TECHNICAL EVALUATION REPORT

This Technical Evaluation Report (TER) documents NRC staff's comments on the Phase 1 DP for WVDP. The TER also includes NRC's determination of whether the proposed action in the Phase 1 DP satisfies the decommissioning criteria. As such, NRC's review of the Phase 1 DP focuses on information relevant to assessing whether the decommissioning criteria have been met (such as, planned decommissioning activities, radiological status of facilities, dose modeling, and final status surveys). In this review, NRC specifically evaluated how previous request for additional information (RAI) have been addressed in the revised Phase 1 DP (Revision 2). Each section of the TER describes NRC's evaluation and conclusion. In some cases, comments are identified for DOE to address in the course of Phase 1 decommissioning activities. NRC also recognizes, based on past discussion with DOE, that certain operational matters related to decommissioning are appropriately addressed by DOE regulations and Orders and are not within the scope of NRC's review. These operational areas include DOE programs related to project management and organization, health and safety, environmental ma

Figure 1 Site Map Showing Areas to Be Remediated in Phase 1

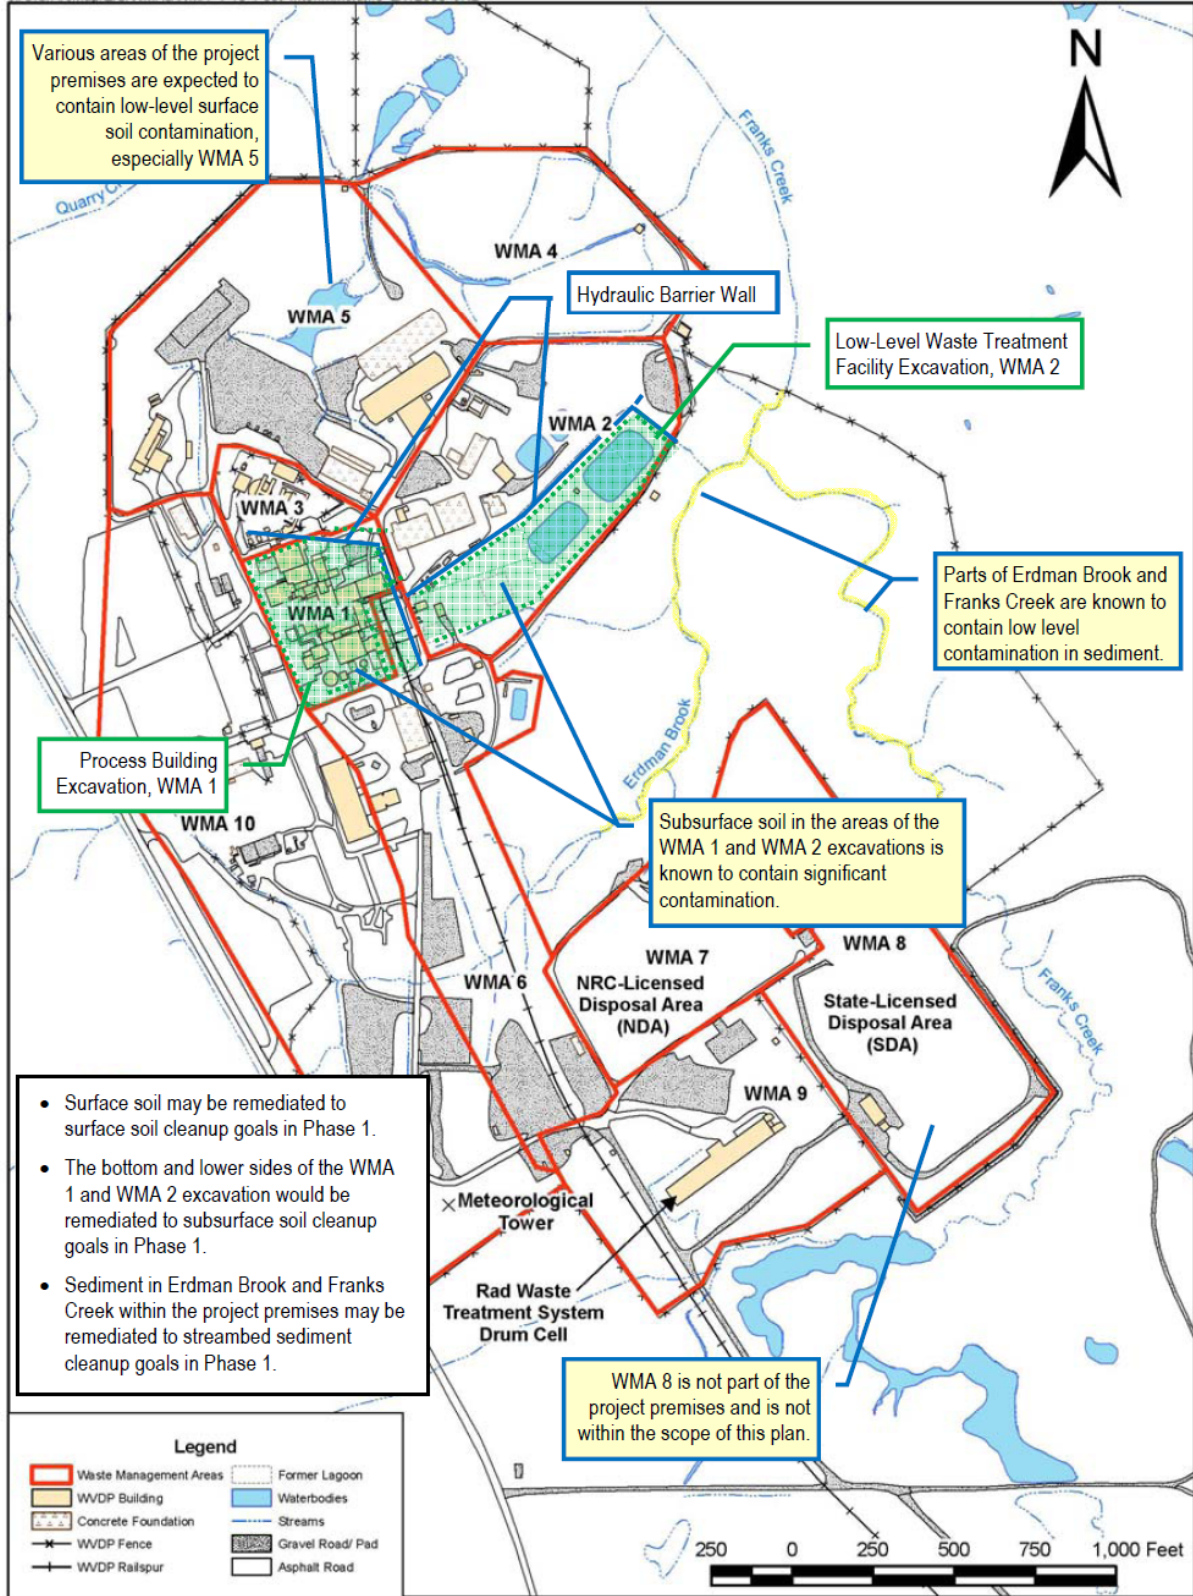
Comment: If previously cleaned areas become re-contaminated, the collection of additional information during the ongoing assessment period reveals that risks are significantly underestimated, or modeling assumptions otherwise become invalid, NRC expects that the impact of these events on the ability of the site to meet LTR criteria will need to be re-evaluated at the time of final decommissioning.

Figure 2 Conceptual Model for Development of Surface Soil DCGLs

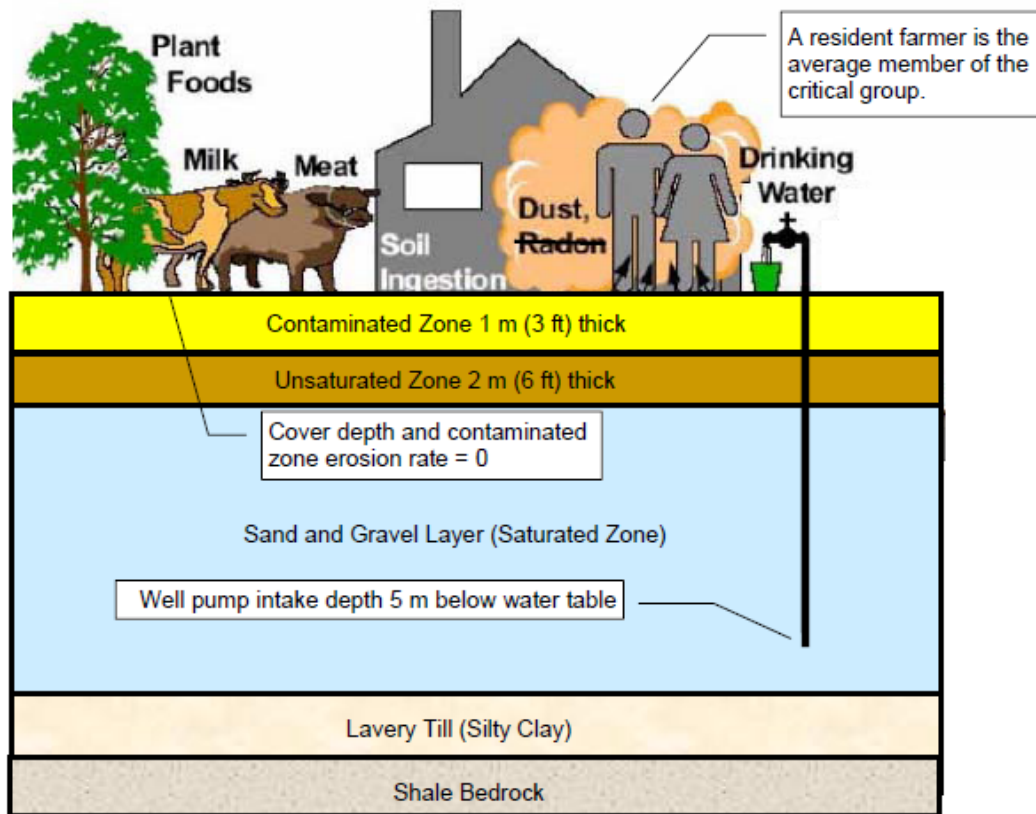
Comment: Dose modeling assumptions regarding the lateral and vertical extent of contamination needs to be verified in the field. If significant deviations exist, DOE needs to: (i) evaluate the risk significance of these deviations; and if necessary; (ii) revise the DCGLs; or (iii) apply the DCGLs to just those areas of the site where the dose modeling assumptions are valid. This comment applies to surface, subsurface, and streambed sediment soils.

Figure 5 Alternative Conceptual Model for Development of Subsurface Soil DCGL: Groundwater Transport (Diffusion) From Lavery Till to Backfill Sediments with Subsequent Well Withdrawal

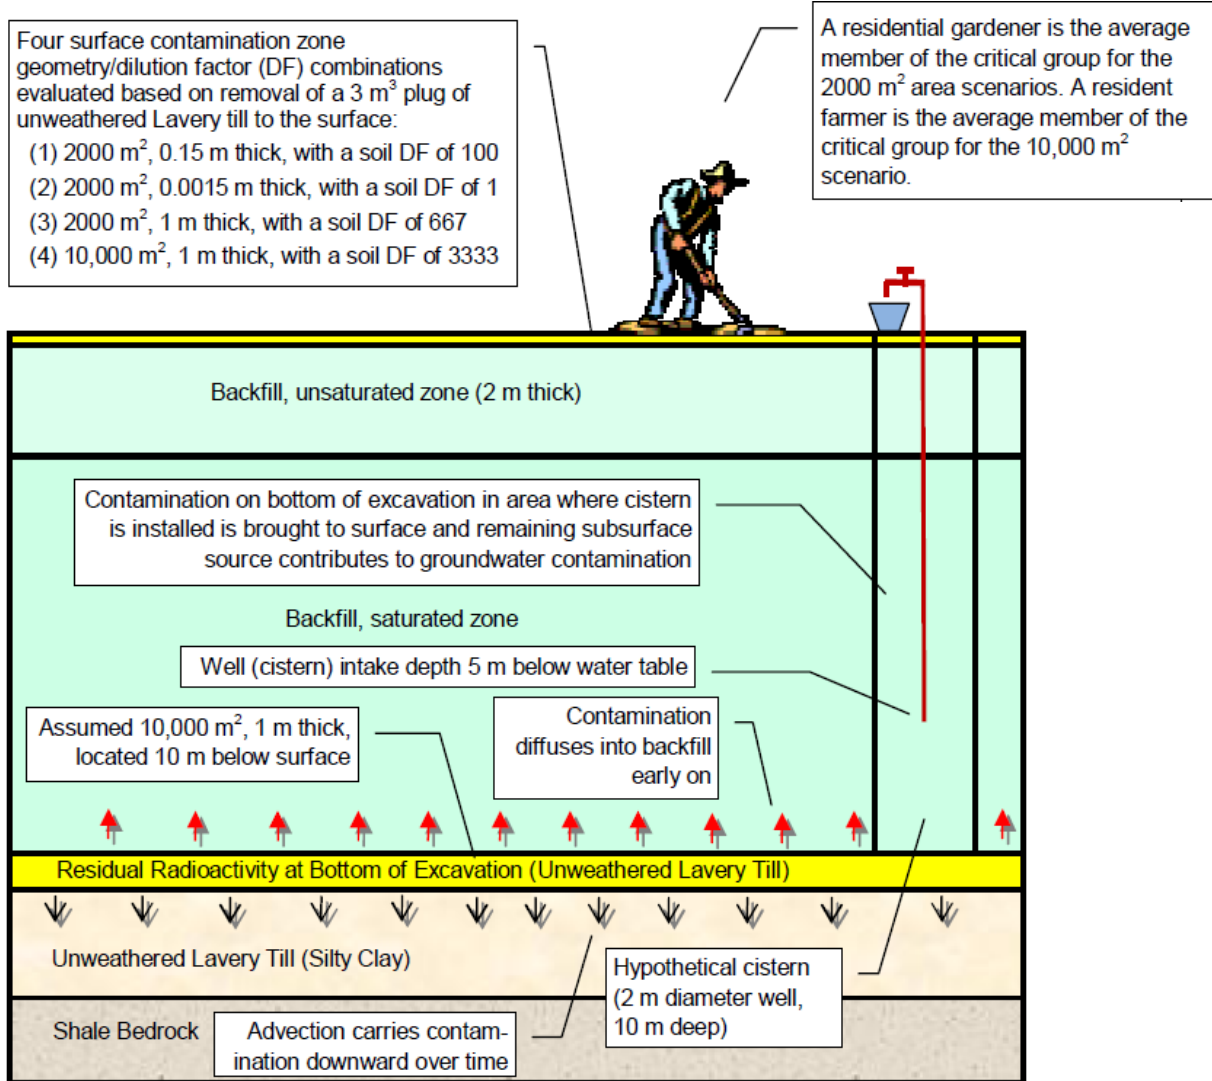
Comment: DOE did not demonstrate that diffusive transport is the dominant transport mechanism of contamination from the lavery till into the overlying aquifer. DOE needs to more formally document its conclusion that advective flow from the lavery till to the backfill sediments is not the dominant transport mechanism for the groundwater transport (or multi-source) scenario.

Figure 8 - DOE's Proposed Use of Permanent Engineered Barriers for Phase 1 Decommissioning Activities and Associated Monitoring Locations

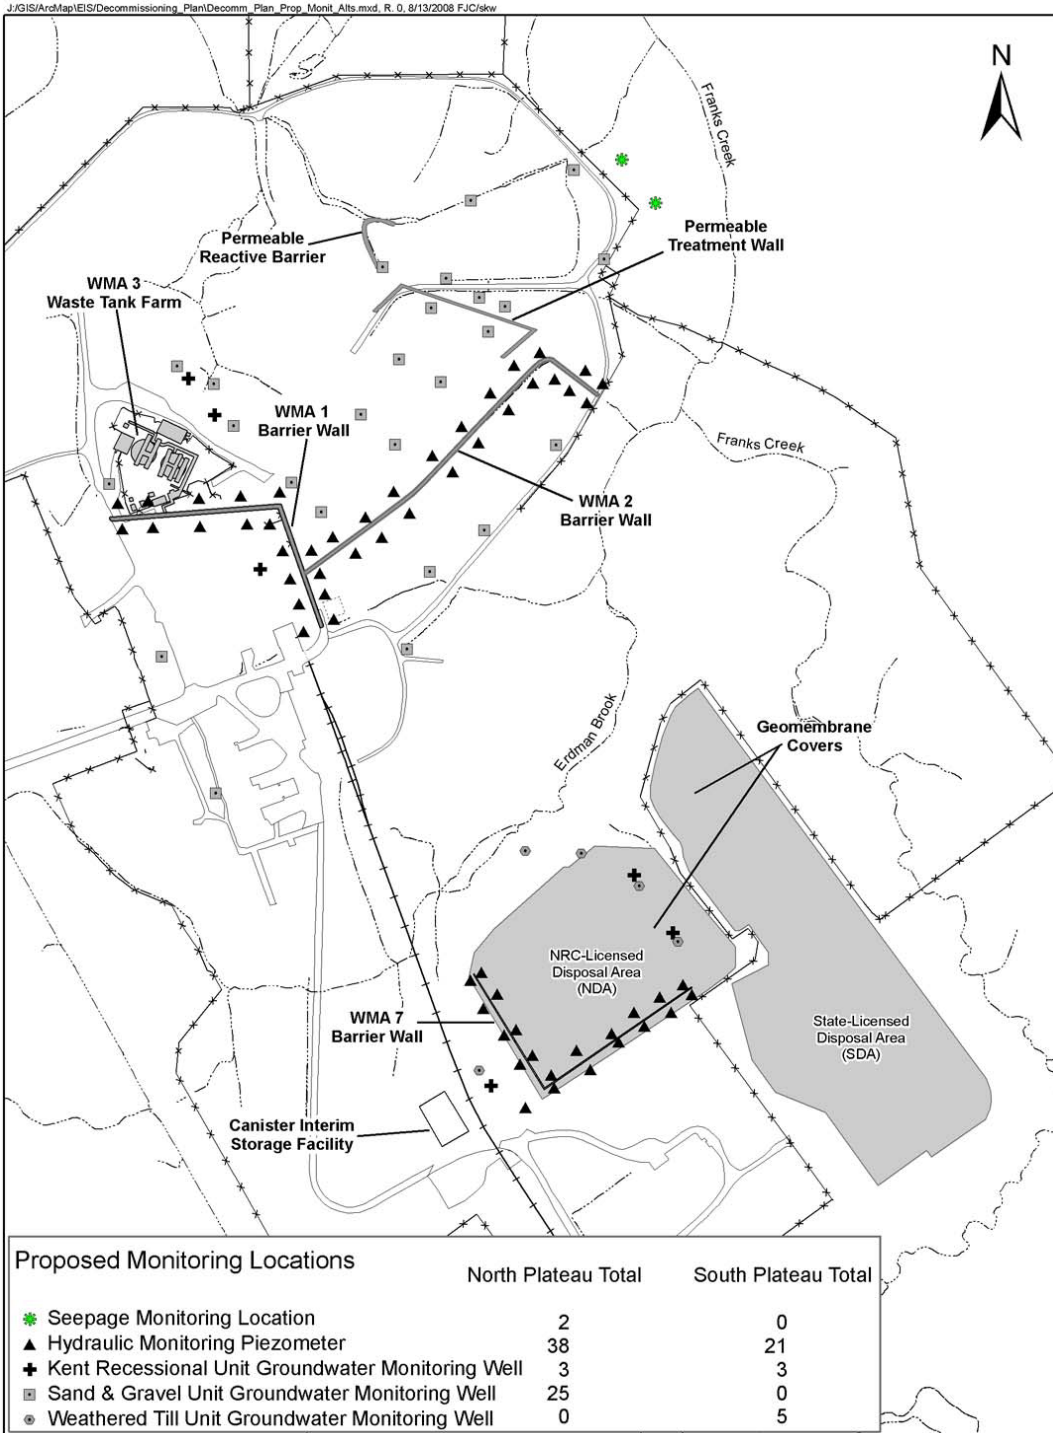
Comment: Potential adverse impacts of final engineered barrier designs have not been evaluated at this time. DOE needs to evaluate any potential adverse impacts of final engineered barrier designs that may affect risk calculations to support Phase 2 decision-making.
